Hi-Fi Products  
**Service Bulletin**

**CSA-13**

**Model:** MHC-1600/3600, CDP-H3600, HCD-H1600      **No. 386**

**Subject:** CD Synchronize Feature Inoperable Following Repair of Unit.      **Date:** March 18, 1994

[BD BOARD](CONDUCTOR SIDE)

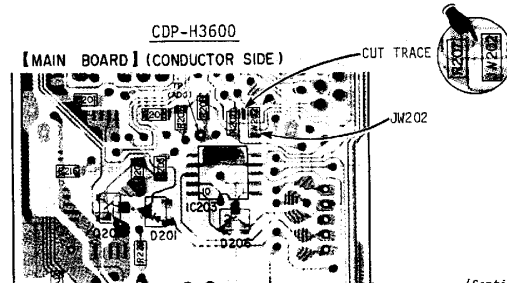
Following replacement of the MAIN Board, BD Board or Micon uPD75116GF, the CD synchronize feature becomes inoperable. This symptom occurs after any one of the following repairs have been made:

The version of the replacement micon uPD75116GF has been updated which results in mis-communication between it and the DSP IC. The following circuit change(s) should be made:

CDP-H3600 (MAIN Board):  
Cut the pattern connecting pin 18 of IC201 to JW202.

HCD-H1600 (BD Board):  
If jumper wire J201 exists on pin 18 of IC202, then remove J201.  
If jumper wire J201 does not exist on pin 18 of IC202, then add a jumper wire from pin 18 of IC202 to GND.
